Project: Lots 17-19, Block 1; Lots 5-8, Block 2; and Lots 1-12, Block 5; and Dedicated Public Right-of-way for Glenwood Drive and Arapahoe Street of Sun Valley Estates

Subject: Preliminary Plat Review

PROJECT: Sun Valley Estates Subdivision Phase 2
LOCATION: Summerset, South Dakota
DATE: April 10, 2020
TOPIC: Responses to Preliminary Plat Review Comments

SUN VALLEY ESTATES SUBDIVISION PHASE 2

TITLE:
GLENWOOD DRIVE
PLAN & PROFILE
STA. 0+00 - 5+00

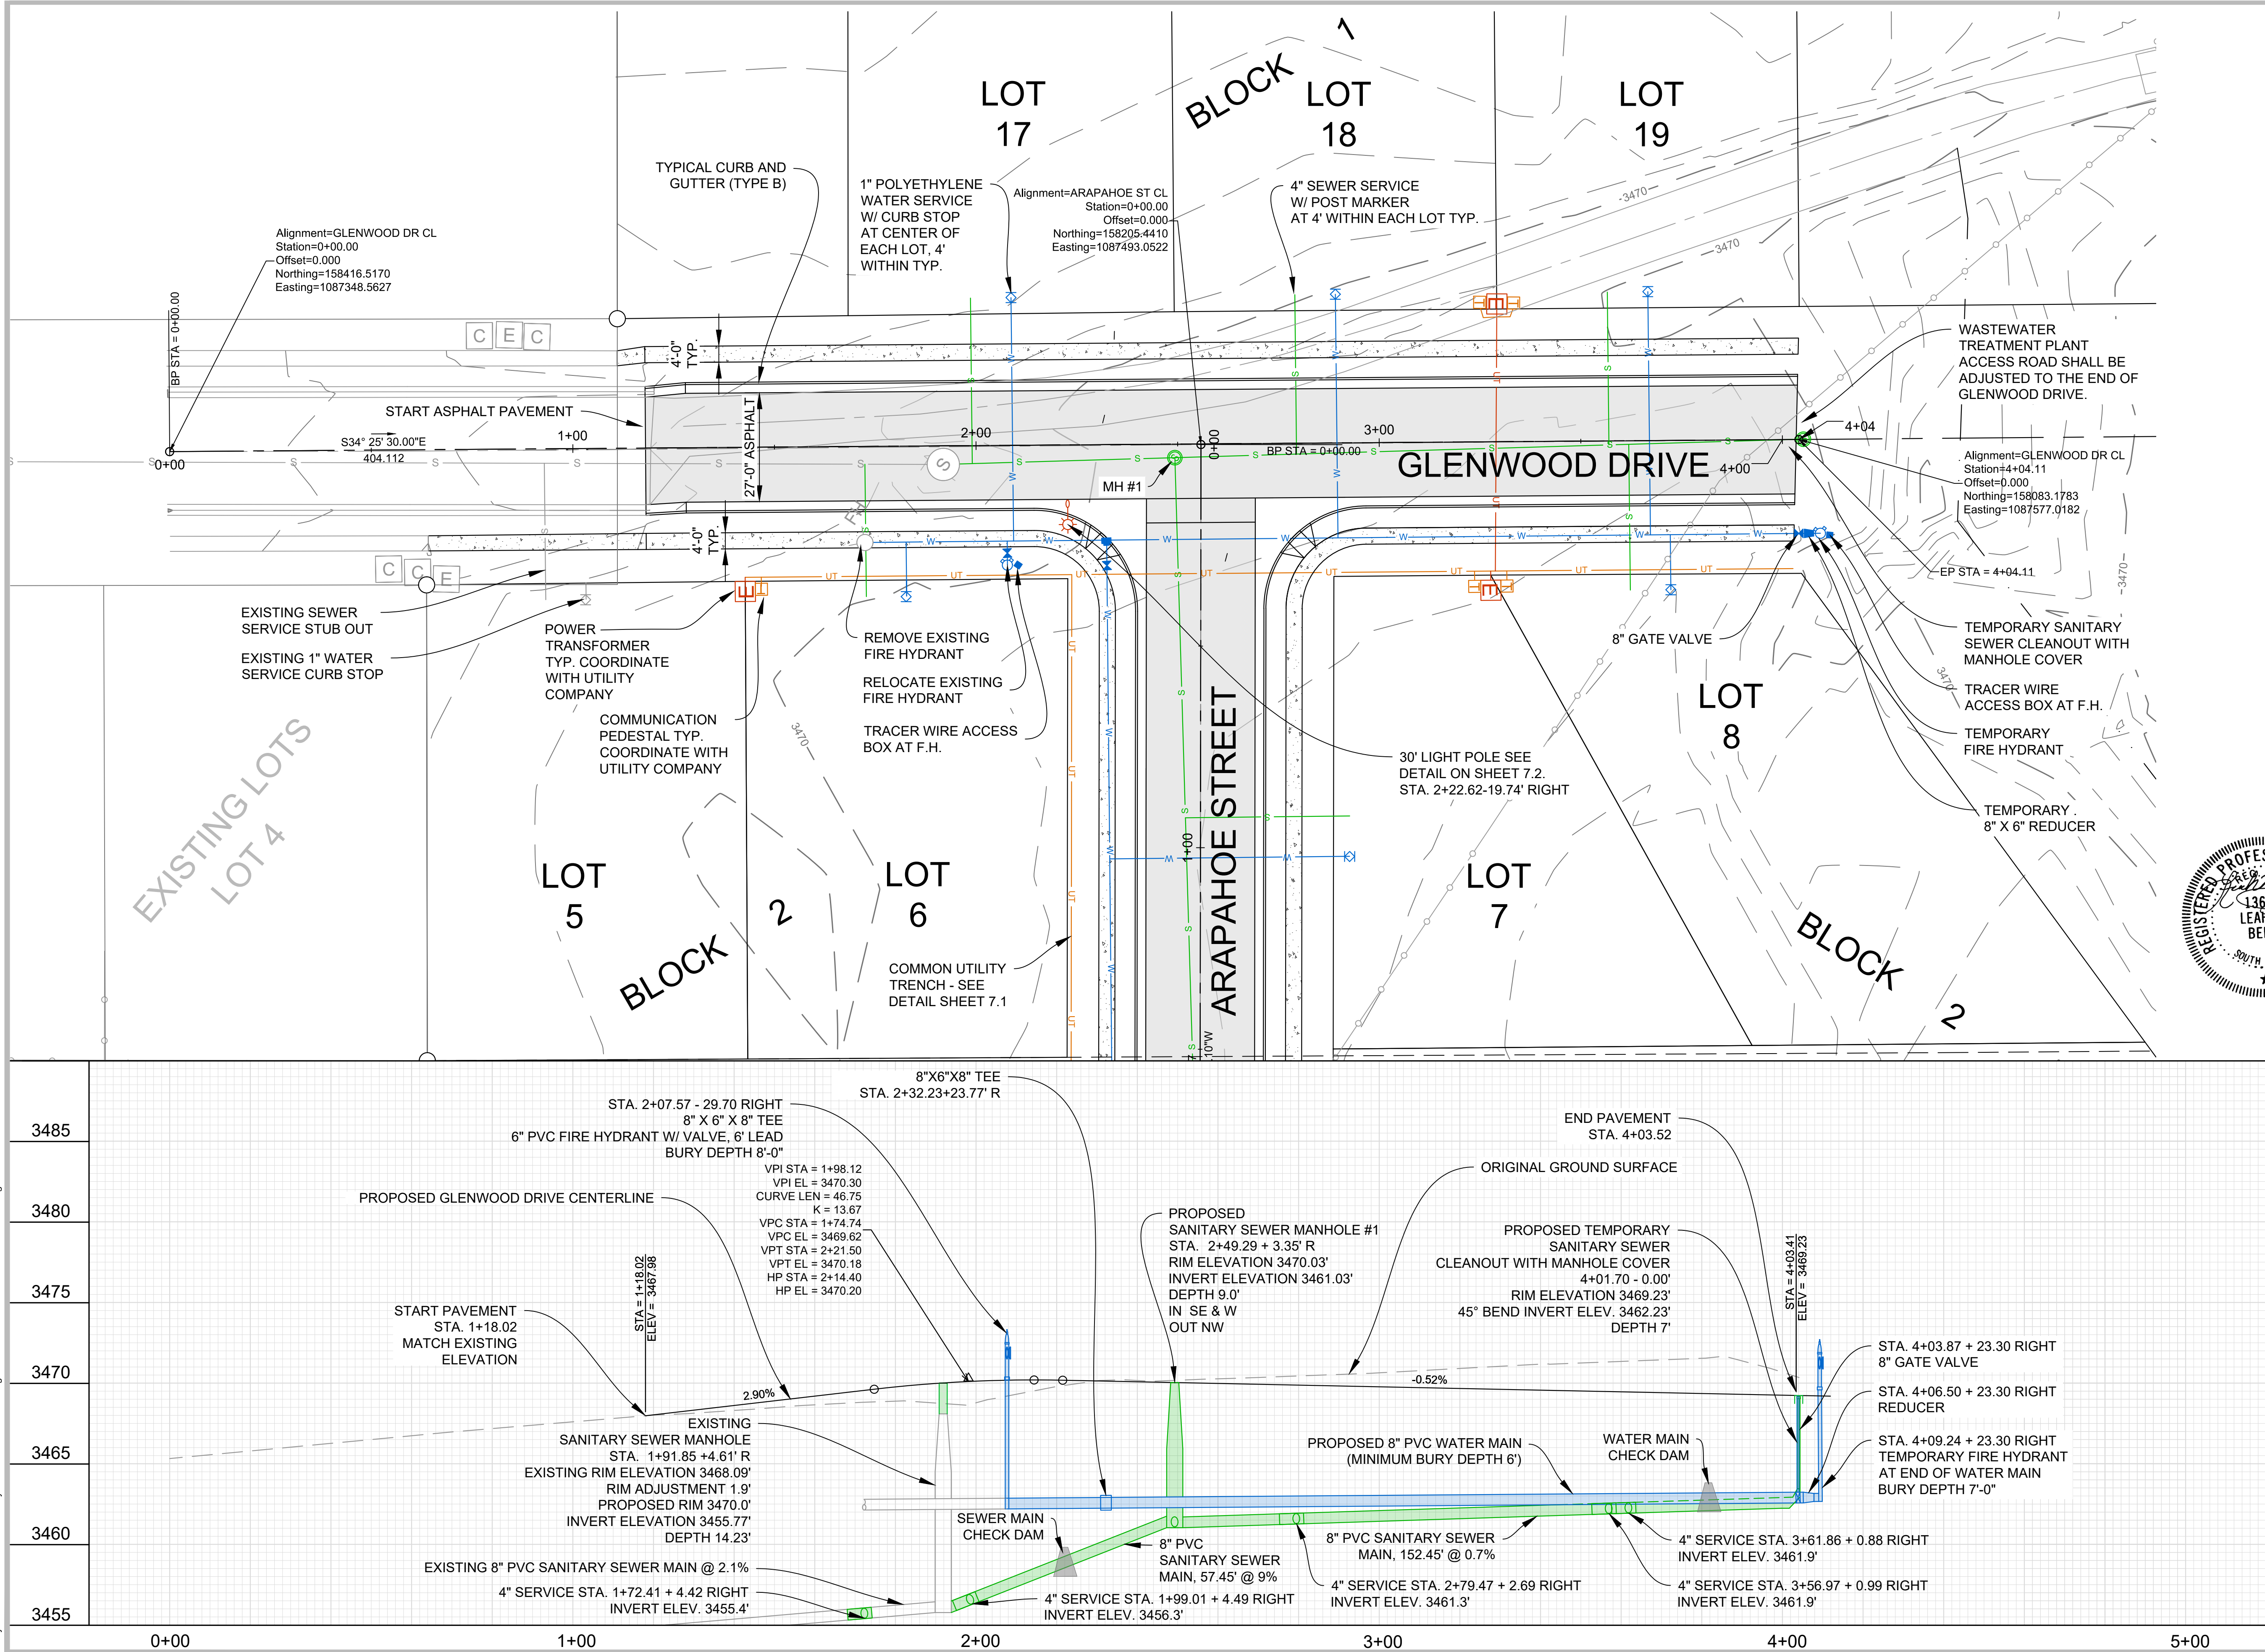
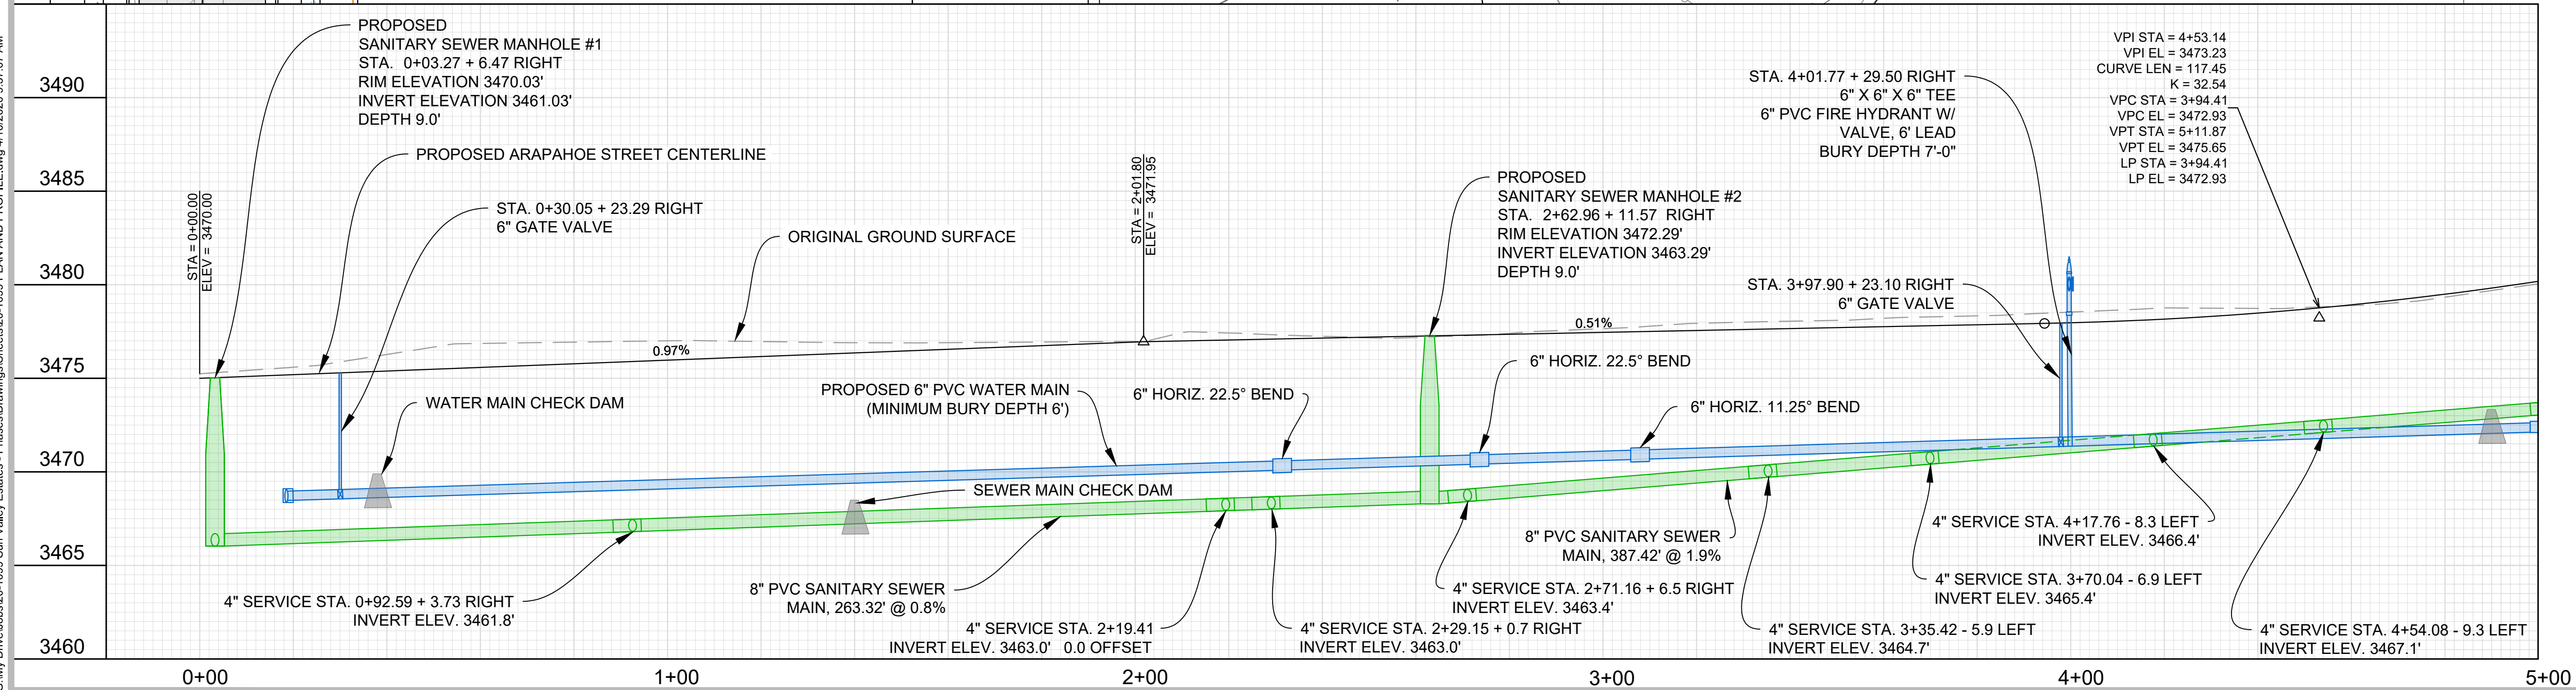
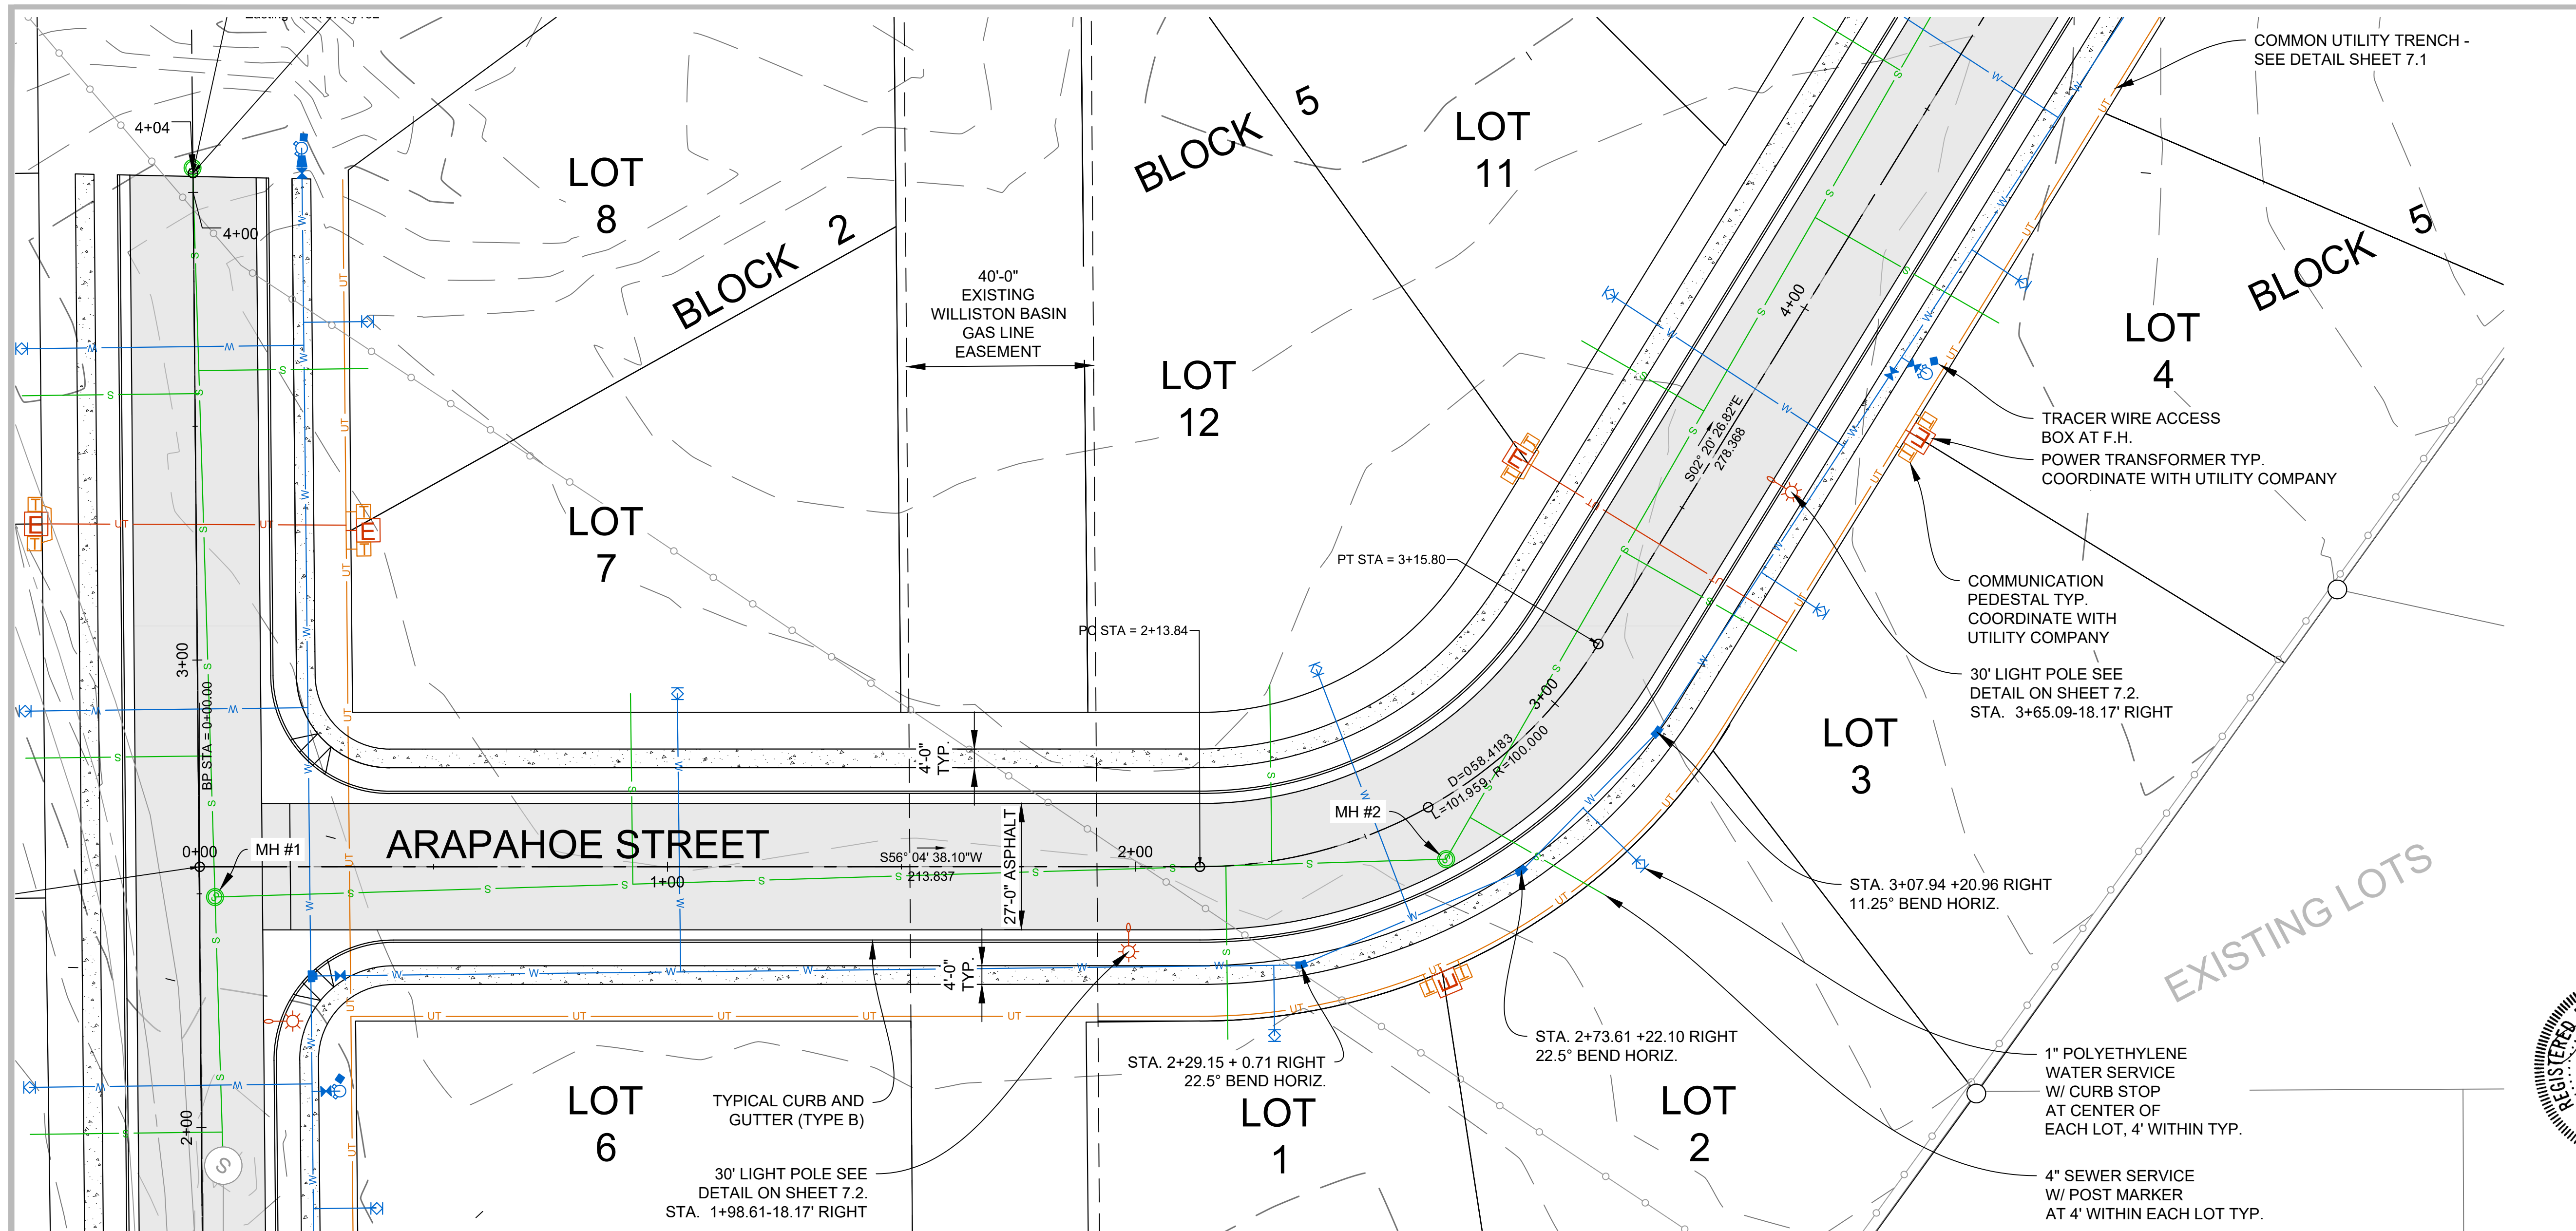
5. Why does the proposed Glenwood Drive roadway jog at the connection to the existing Glenwood Drive?
6. PI shown at approximately Station 2+12 needs to be a vertical curve. We only allow a PI without a vertical curve in the road profile if the change in grade is 1% or less.

8. Why is there such a steep grade in the sewer between the existing manhole in Glenwood and Manhole #1?

5. Why does the proposed Glenwood Drive roadway jog at the connection to the existing Glenwood Drive?
Response: We have the new roadway centered in the ROW. If there is a jog it would be a slight adjustment in the field with a smooth transition.

6. PI shown at approximately Station 2+12 needs to be a vertical curve. We only allow a PI without a vertical curve in the road profile if the change in grade is 1% or less.

Response: A vertical curve has been added at this location.

8. Why is there such a steep grade in the sewer between the existing manhole in Glenwood and Manhole #1?

Response: This location is the transition point to allow the new sanitary sewer main to be located at a responsible depth of 9' not 14'+. Based on future phasing, this will support future expansion of Glenwood and Arapahoe as well.
